SUPPLEMENTAL FEIS ENVIRONMENTAL IMPACT STATEMENT (SFEIS)

River Knoll

**40 CROTON DAM ROAD
TOWN OF OSSINING
WESTCHESTER COUNTY, NY**

Date: **December 2022**

**On-site Delineated Wetlands
 Figure 3.B-3**

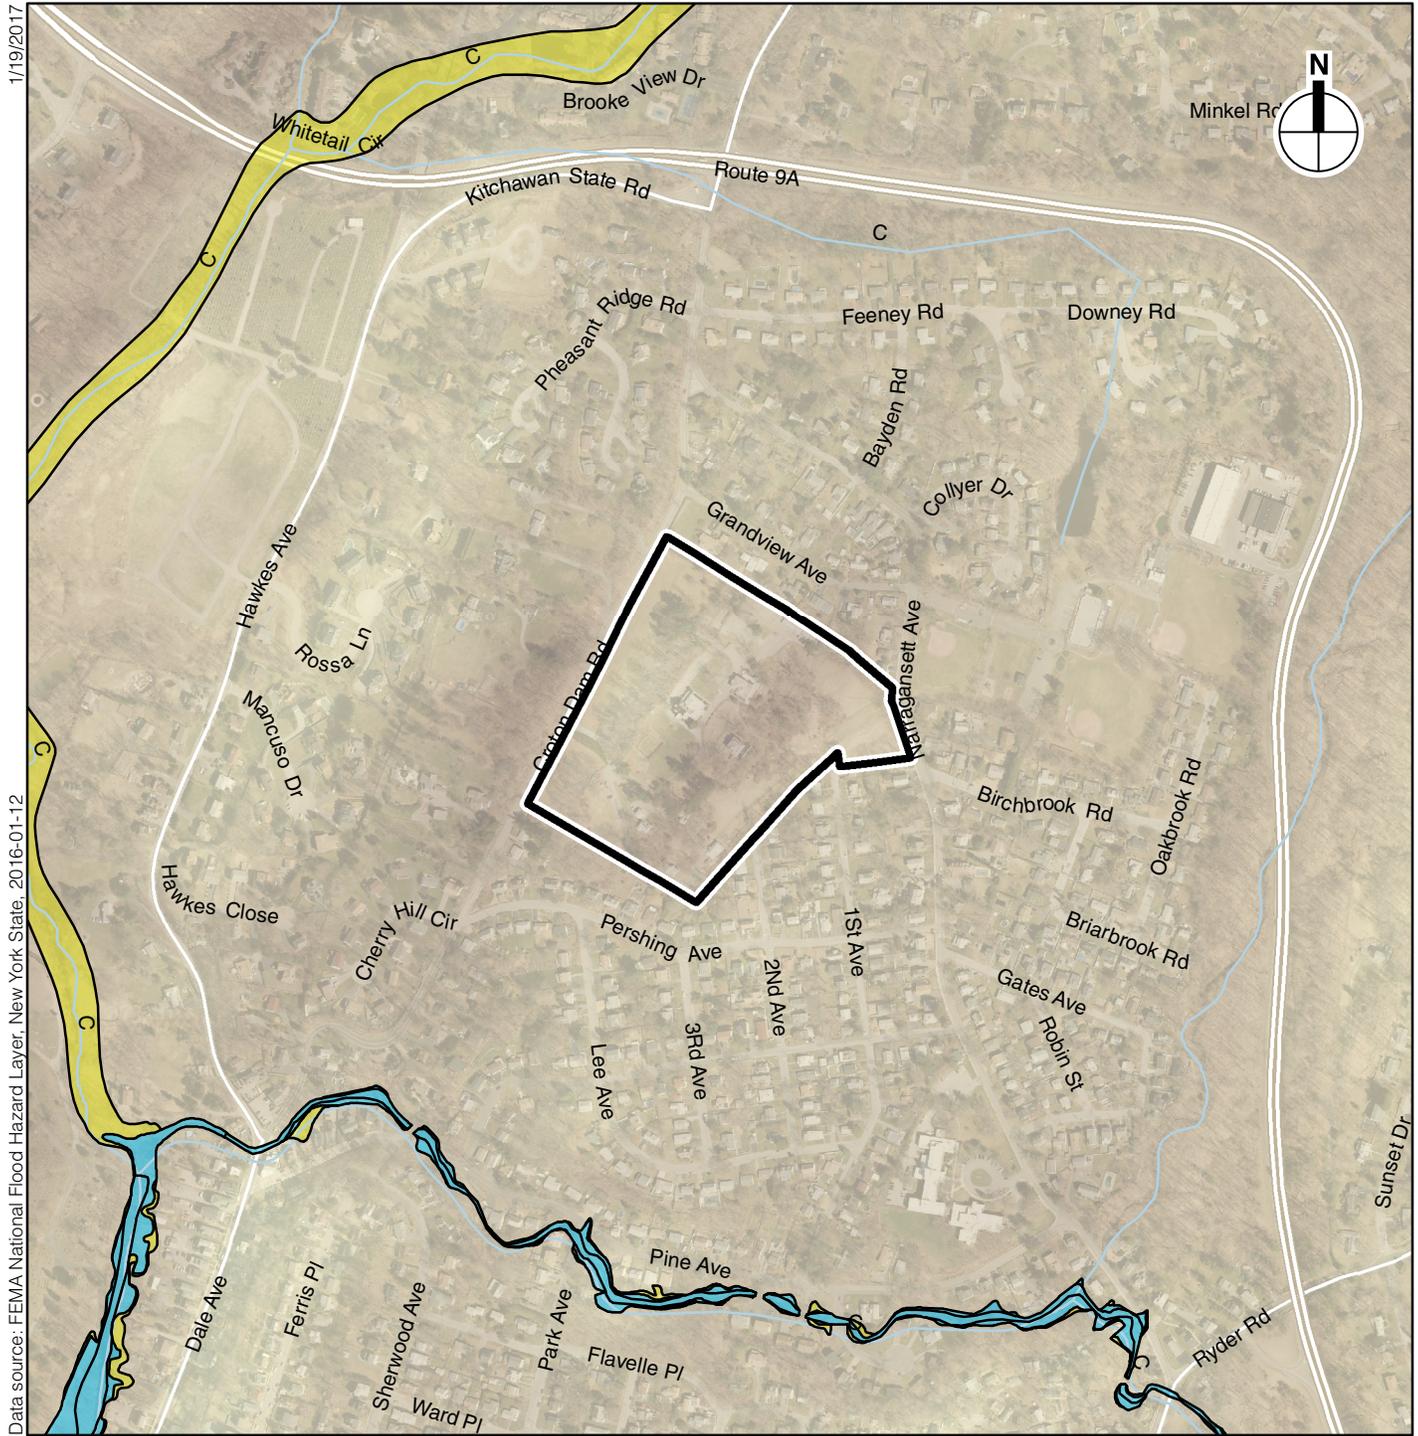
Section III.B.2.i indicates that “the inspections confirmed one small herbaceous wetland of approximately 0.146 acres in size in the northeastern portion of the Project site (see Figure 3.B-3). The wetland is located entirely within the Village of Ossining. The wetland buffer in the Town portion of the site is 0.496 acres in size.” However, III.B.1 indicates that the delineated wetlands within the boundary of the Former Project as such: “a small herbaceous wetland was delineated on-site on September 14, 2015. This wetland was 0.277 acres in size, of which most, 0.273 acres, was located within the Village of Ossining. A smaller amount, 0.004 acres, was located within the Town of Ossining.” Are these statements referencing the same wetland areas? If so, please explain in further detail the discrepancies in size (i.e., why has the wetland area decreased almost by ½ in size from 2015 to 2021?)

This figure has been revised to address the comment (see Figure 3.B-3).

SECTIONS

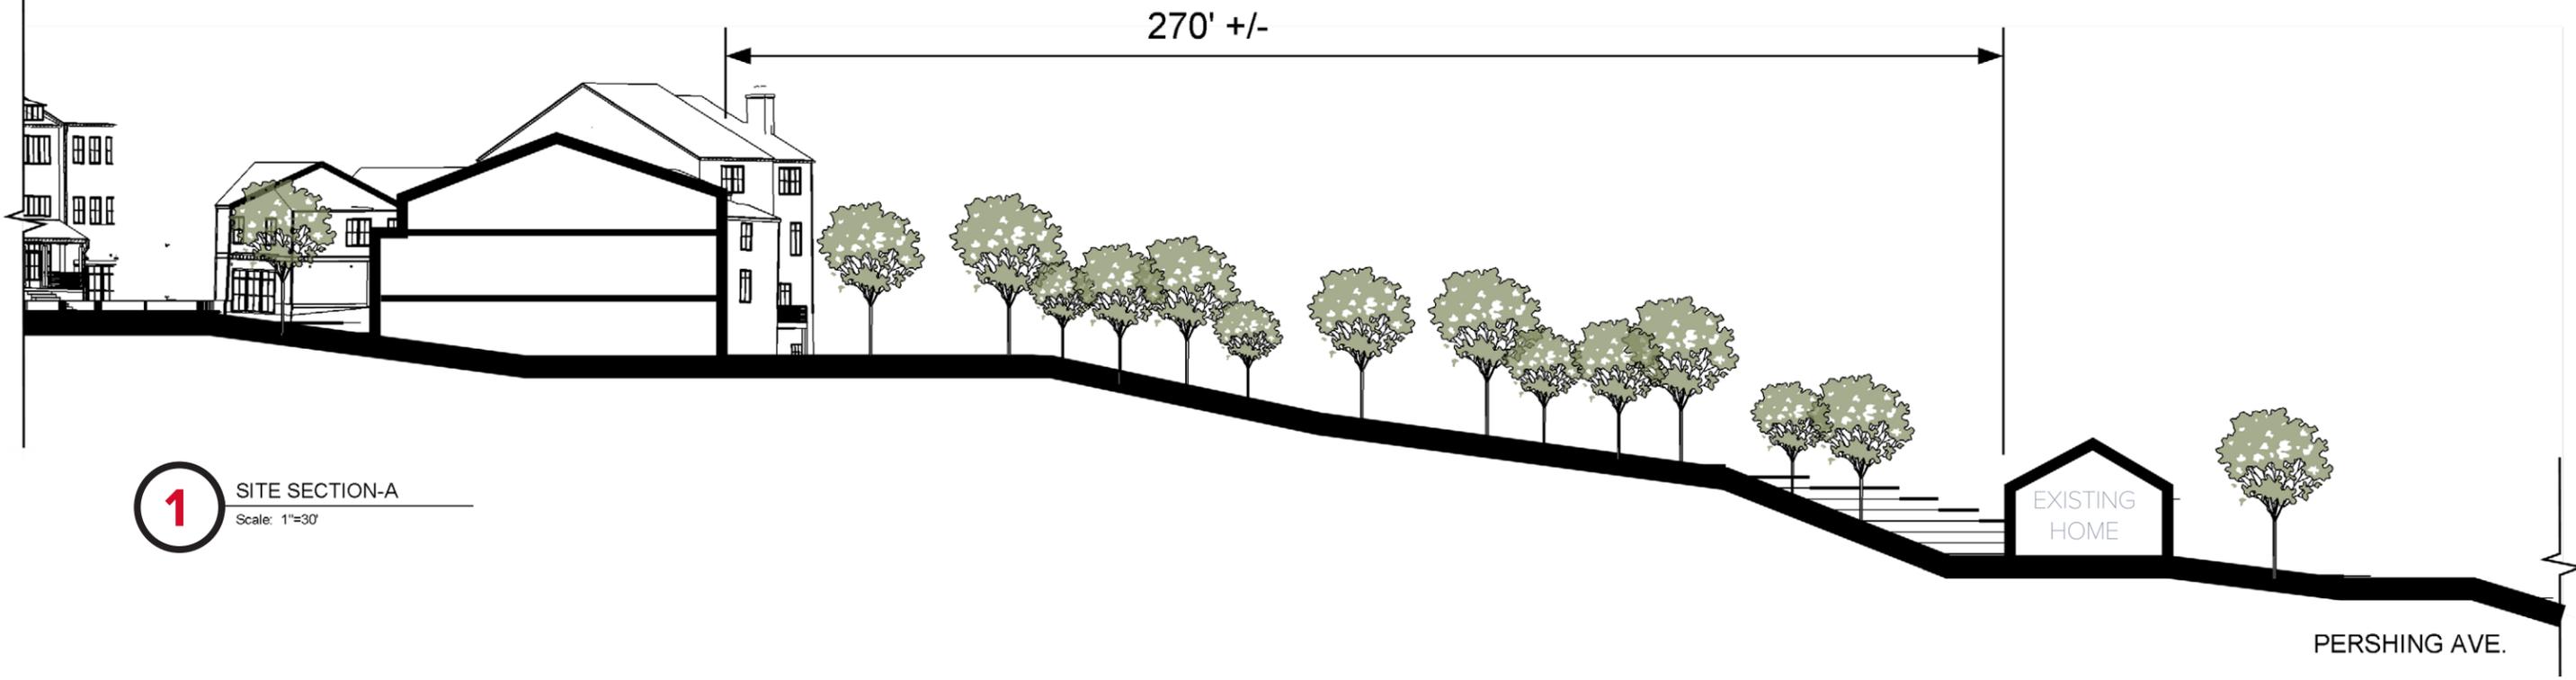
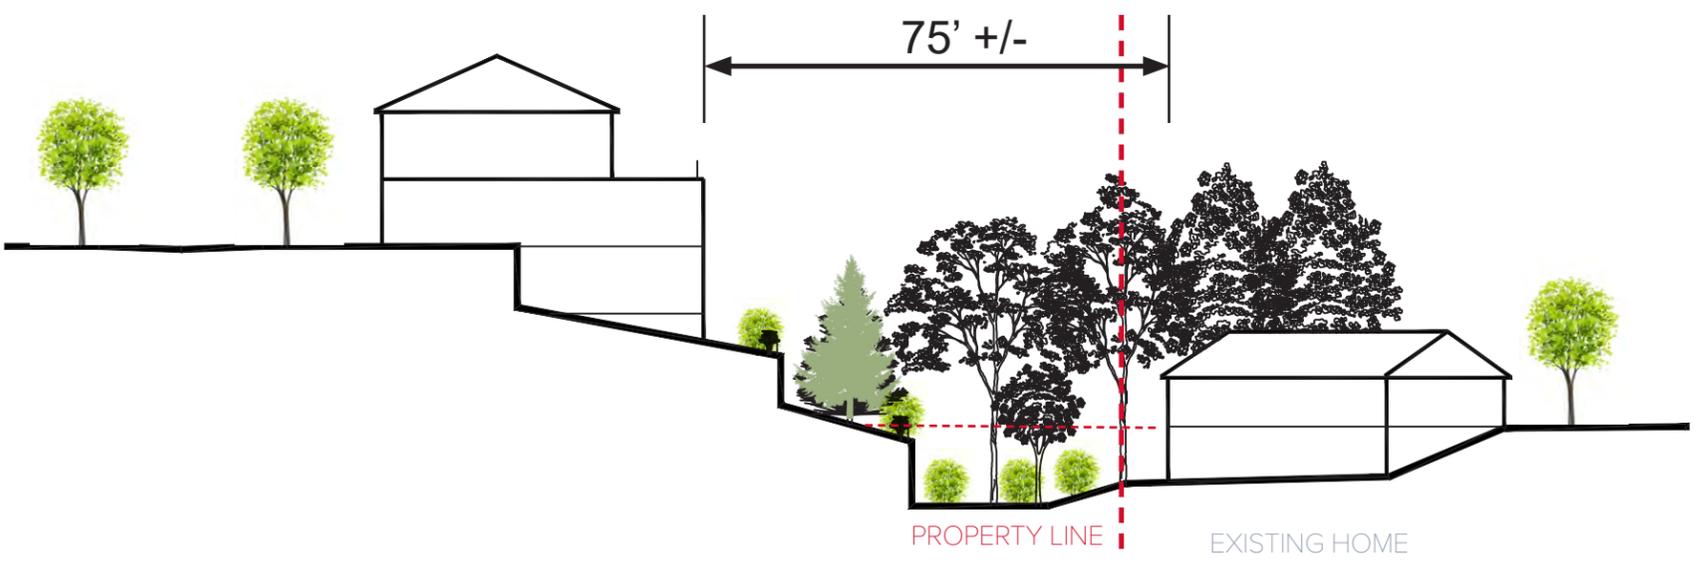
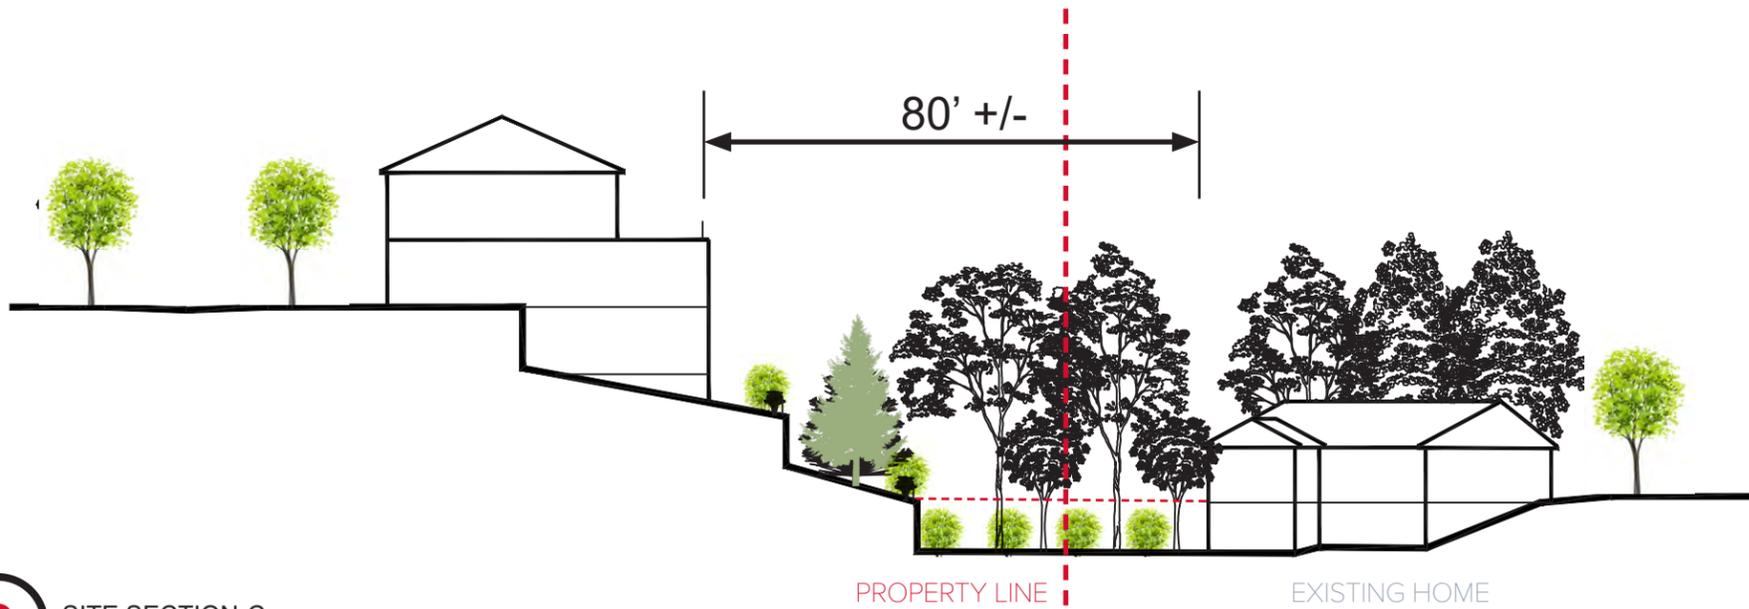
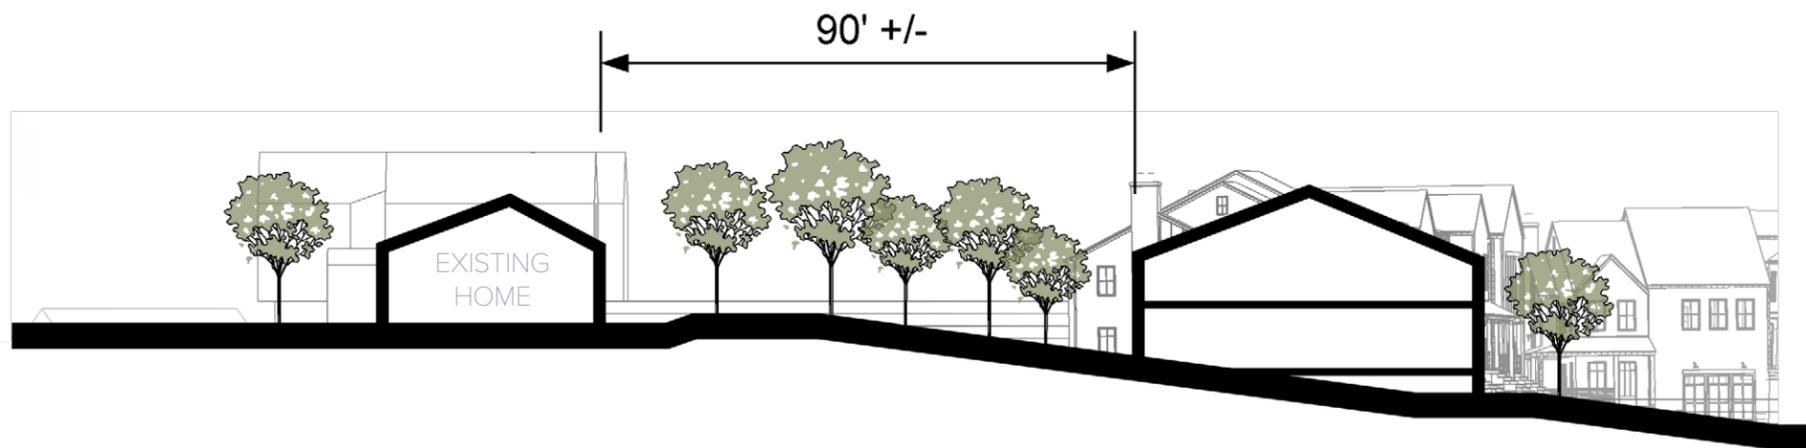
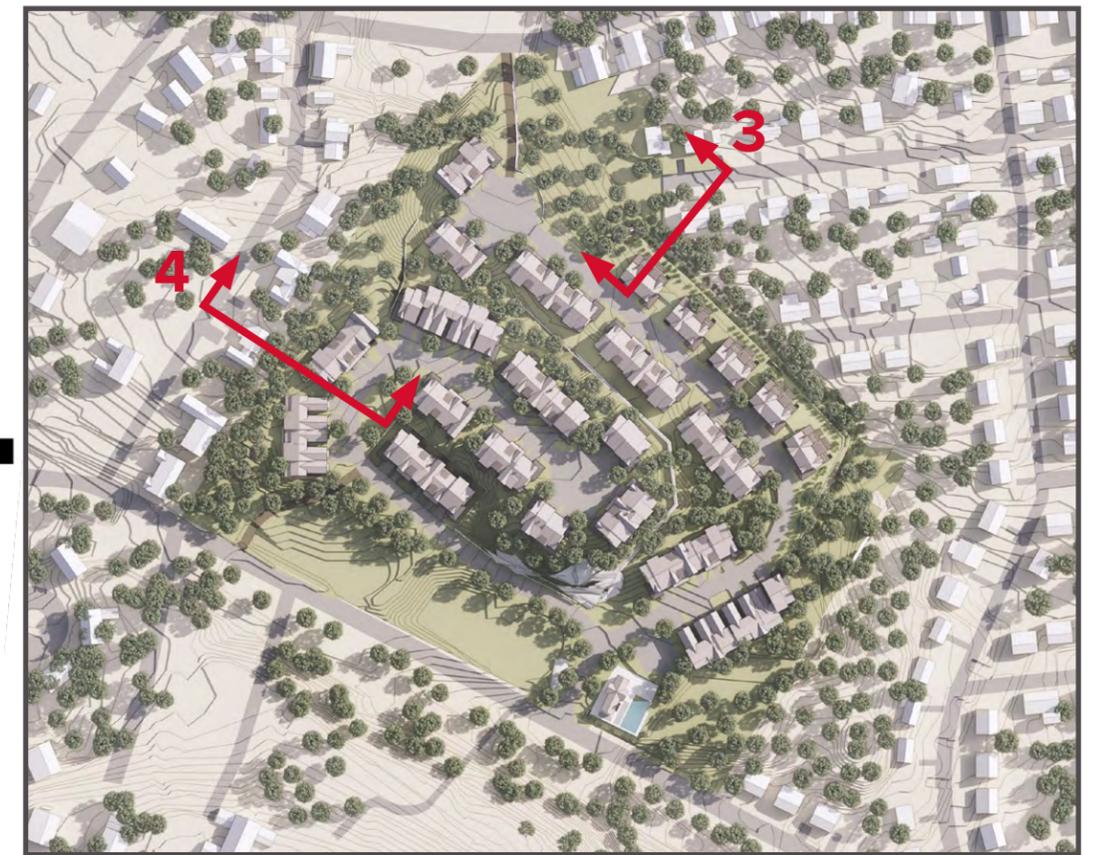
Section III.A.2.i does not provide a discussion of the visual analysis found in Appendix H. A discussion of the impacts and any proposed mitigation should be included. The model does not depict the retaining walls and landscaping as they are shown on the site plan. All simulations should include the proposed retaining walls as depicted on the site plan and proposed landscaping as per the landscaping plan. Please revise the images in Appendix H or revise the site plan to show the tiered retaining walls.

d). These dimensions are incorrect and a more detailed plan with sections of the retaining wall alongside the homes on First and Second Avenues is contained in

Appendix C and these retaining are at their highest approximately 8 feet. The height of these walls will be further reduced in perceived height as drainage gravel will be placed at the base of the lowest wall. Additionally, the walls will be fully landscaped with ornamental grasses and plantings.

f). The proposed setbacks of the townhouses are considerably greater than the setbacks of the homes to which the Project abuts. The redesign of these townhouses has increased the setbacks from the Property line, has lowered these units by a full story, and significantly reduced the number of units from thirty-two units (32) to only ten (10) units. As previously stated, additional detail of the retaining wall and townhome foundations are contained in Appendix C.
